# Zoning Staff Report

Date: August 13, 2024 Case Number: ZC-24-054 Council District: 8

# **Zoning Map Amendment**

Site Location: SE Corner of McPherson Rd and Forest Hill Everman Rd Acreage: 11.66 acres

ZONING SITE PLAN ZC-24-XXXX

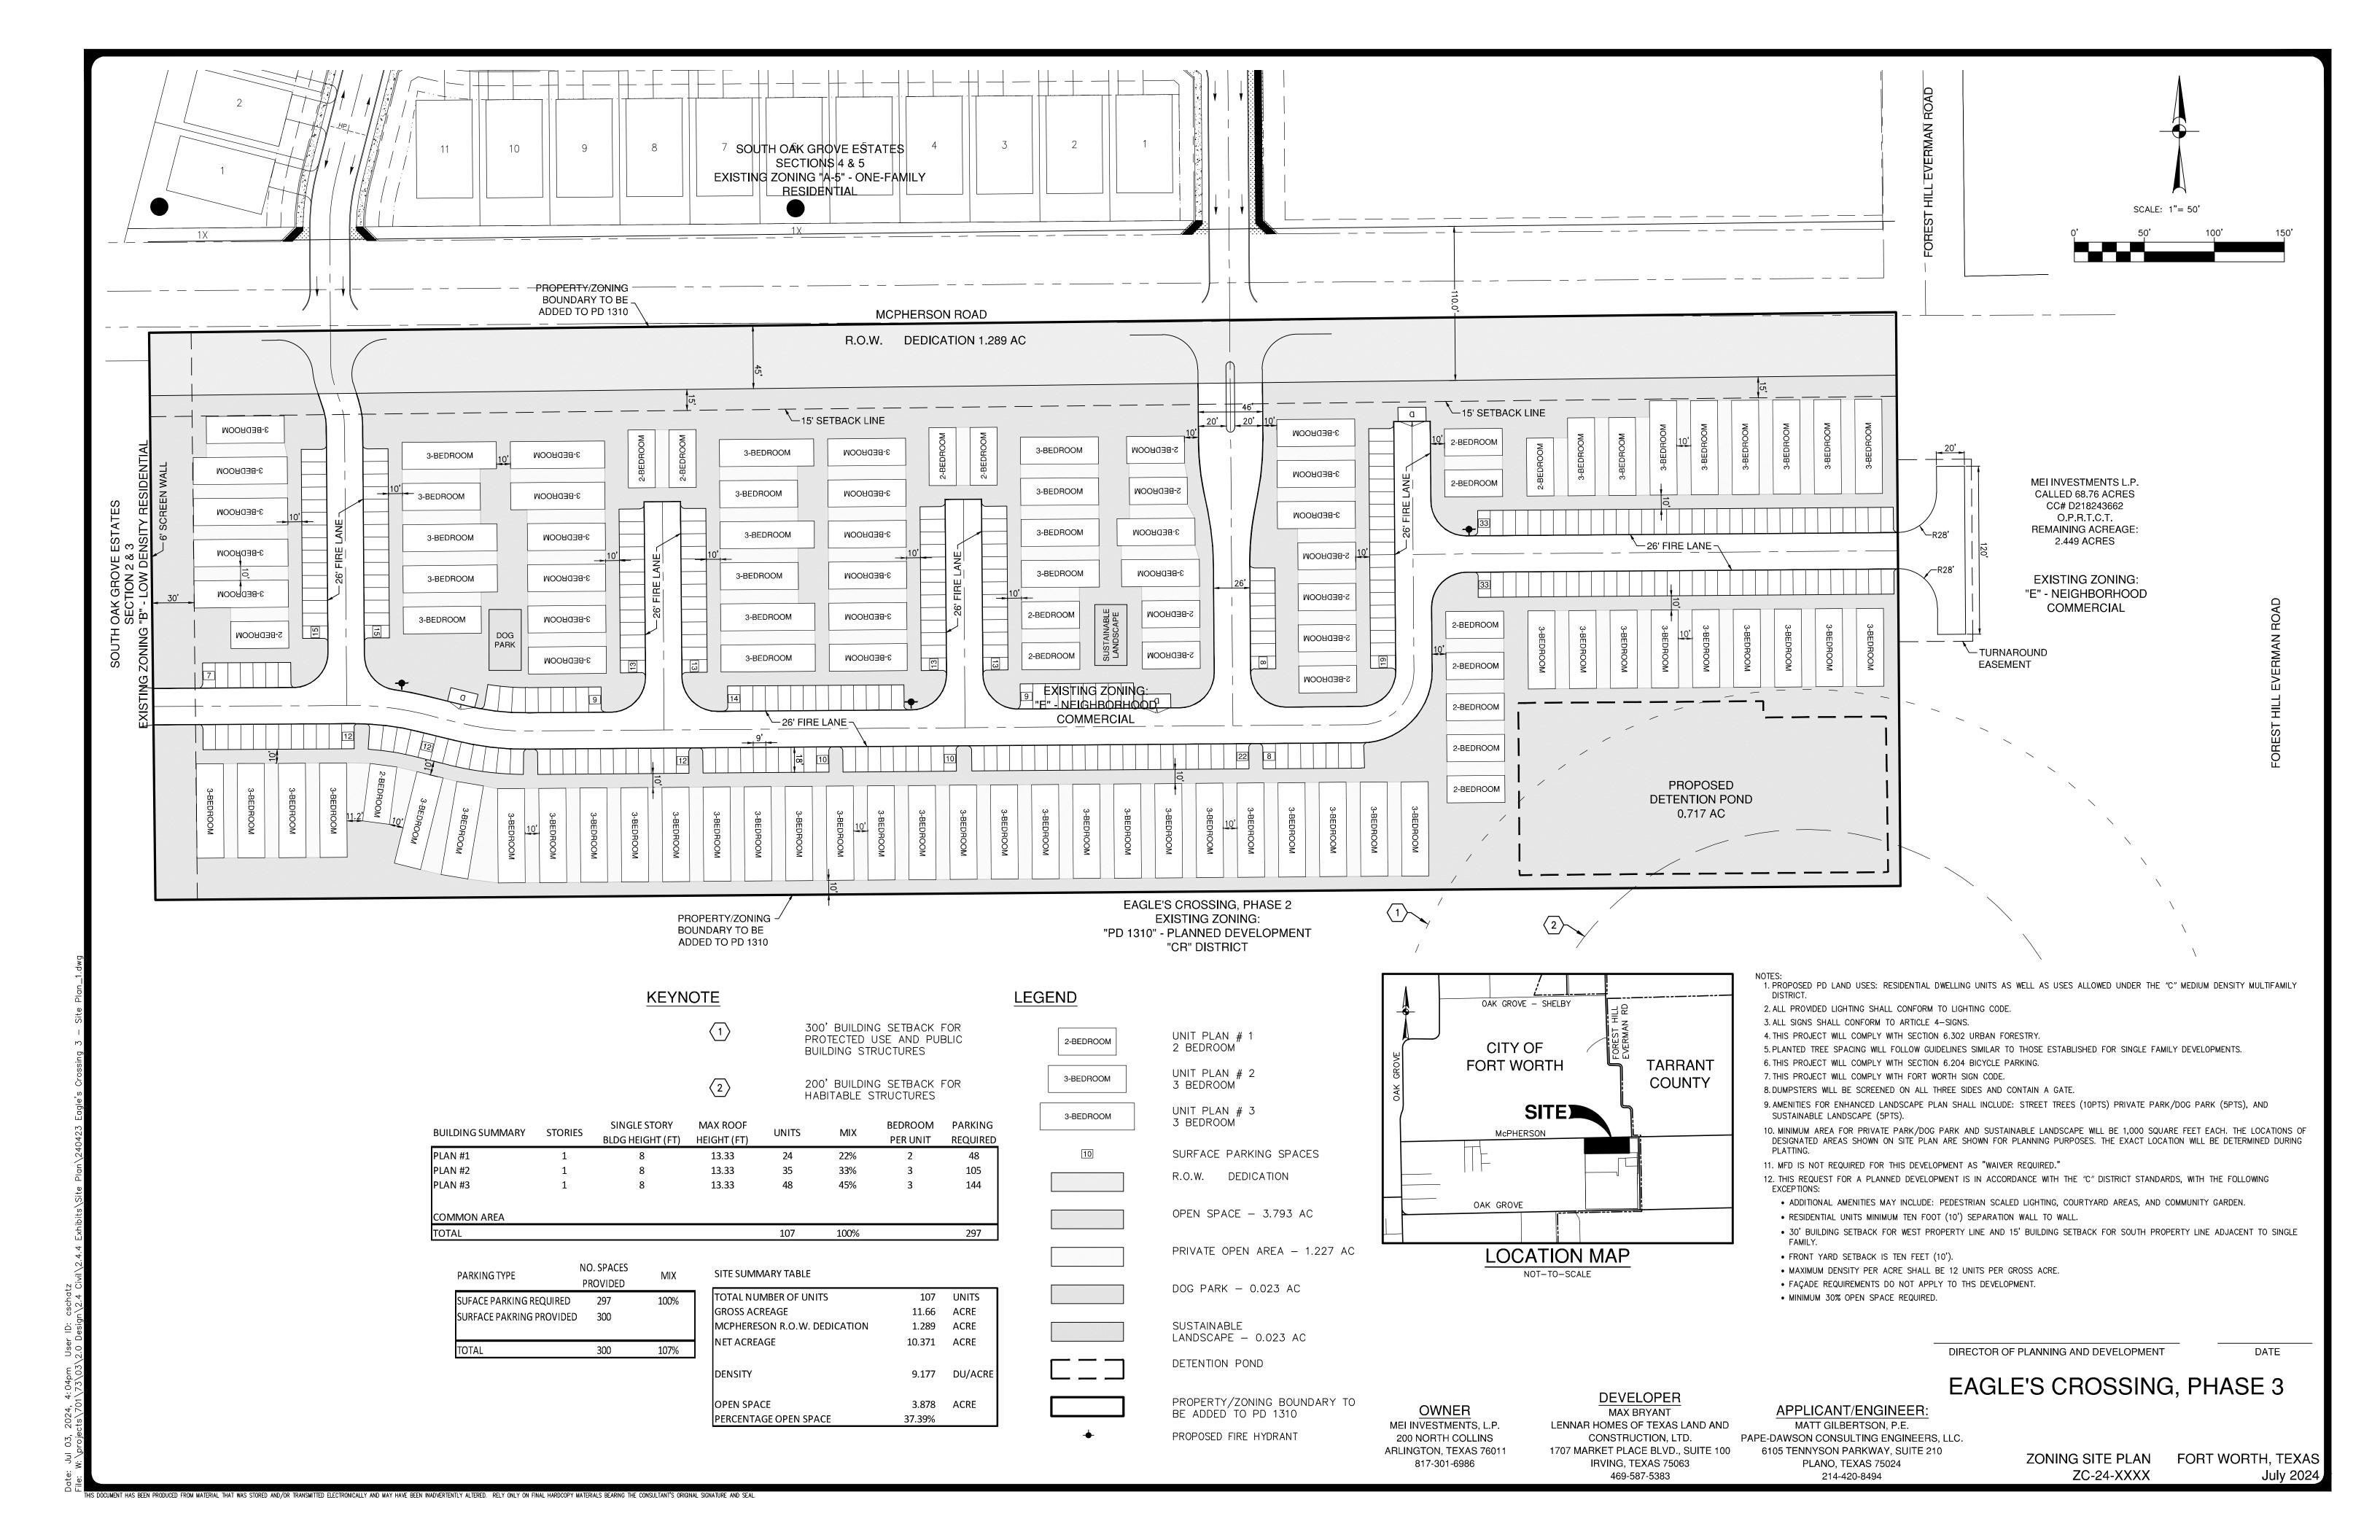
Standard	C Zoning	Proposed PD/C	Staff Recommendation
Setback	Setback adjacent to one- or two-	Providing 30 ft	Support (detached
	family residential district Three	(Development Standard	multifamily often has
	feet for every one foot (3:1) as	Required)	single-family
	measured from slab to top of		characteristics)
	sill plate (roughly 39 ft)		
Building Height	36 ft	13 ft (Will Comply)	NA
Fencing	Not allowed in front of building line	Located in front of the	
		building ( <b>Development</b>	Denial
		Standard Required)	
Parking	Parking not allowed in front of the building	Located in front of the	<b>Denial</b> (parking can be
		building along Forest	moved to accommodate
		Hill/Everman Road	development)

(Development Standard Required)	
Open Space	45% required	37 % provided (Development Standard Required)	Denial
Density	9 units per acre	Will Comply	NA
Building Orientation	Buildings located on public streets must face the street with the longest length of the building placed parallel/adjacent to the street		Denial

• See Dev standards in the chart above

- Updated drainage study required prior to platting, commercial grading permit issuance, and building permit issuance.
- No FEMA Floodplain, City Flood Risk, or Potential High Water on site. There is a detention pond (SWFMA-22-0098) located to the south of the site that was constructed and designed under the original drainage study, DS-21-0125.

- Internal Emergency Access Easements will need to be named. The Fire Department will assist you with that during the platting phase. I attached the standards for street names. Email Fireplatting@fortworthtexas.gov to request approval for street names prior to FINAL PLATTING. Please include the subdivision name and plat number in the subject line.

- Each unit will have its own address. Addresses must be visible from a marked fire lane or street.
- Fire lanes must be a minimum of 20' wide and provide hose lay to the exterior of each structure within 150', measured in a 5' wide unobstructed path from the edge of a marked fire lane or public street. That distance MAY be increased to 300' if the building is equipped with a fire sprinkler system.

- Where divided by a median, fire lanes must be a minimum of 20' on either side of the median.
- Minimum turn radius for fire lanes is a minimum of 25' inside and 51' outside.

- Vehicle gates are required to be a minimum of 20' wide when fully opened and equipped with Knox Locks. Permits are required.
- Hydrant requirements:
  - o ? 600 ft. (300 ft. radius) of space between hydrants along a direct horizontal line

- o ? 500 ft. hose lay distance to all points of building.
  - FDC's for sprinkler and standpipe systems shall be located within 50 ft. of a dedicated street or fire apparatus access road and shall be within 150 ft. hose lay distance of the nearest fire hydrant. Each building shall be equipped with its own FDC, unless otherwise approved by the fire code official.

• PARD-PDP will apply
